Access Compliance Report Public Rights-of-Way (Curb Ramps)

Main Street: SLEEPY_HOLLOW_LN Cross Street: SOMMERVILLE_PL Location: NE

ADA ID: RPRK211021134051 Ramp Type: Type 4 - Parallel Initial Pass/Fail: Fail Overall Compliance: No Severity Score: 2

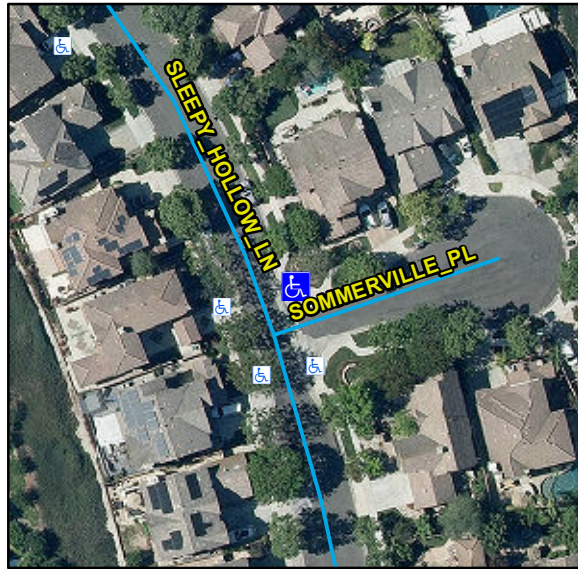
Compliance	Description	Data	Compliance	Description	Data
N/A	Ramp Length LT (in)	115	N/A	Ramp Length RT (in)	117
Yes	Ramp Width LT (in)	53	Yes	Ramp Width RT (in)	54
Yes	Ramp Run Slope LT (%)	7.5	Yes	Ramp Run Slope RT (%)	5
Yes	Ramp Cross Slope LT (%)	1.5	No	Ramp Cross Slope RT (%)	2.9
N/A	Landing Present	N/A	N/A	DWS Provided	N/A
N/A	Landing Length (in)	N/A	N/A	DWS Contrast	N/A
N/A	Landing Width (in)	N/A	N/A	DWS Length (in)	N/A
N/A	Landing Run Slope (%)	N/A	N/A	DWS Full Width	N/A
N/A	Landing Cross Slope (%)	N/A		DWS Offset Type	N/A
N/A	Landing Movement Obstructed?	N/A	N/A	DWS Offset Left (in)	N/A
	Landing Movement Type	N/A	N/A	DWS Offset Right (in)	N/A
N/A	Landing Shared	N/A			
N/A	Clear Space	Yes			
N/A	Clear Space To Crosswalk (in)	N/A			
N/A	Marked Crosswalk 1	No	N/A	Marked Crosswalk 2	No
	Crossing 1 Direction	W		Crossing 2 Direction	S
	Marked Crosswalk 1 Width (in)	N/A		Marked Crosswalk 2 Width (in)	N/A

Remove & Replace Curb Ramp With Two New Directional Ramps or Equivalent.

R204.3, R304.5.3, STD 1115
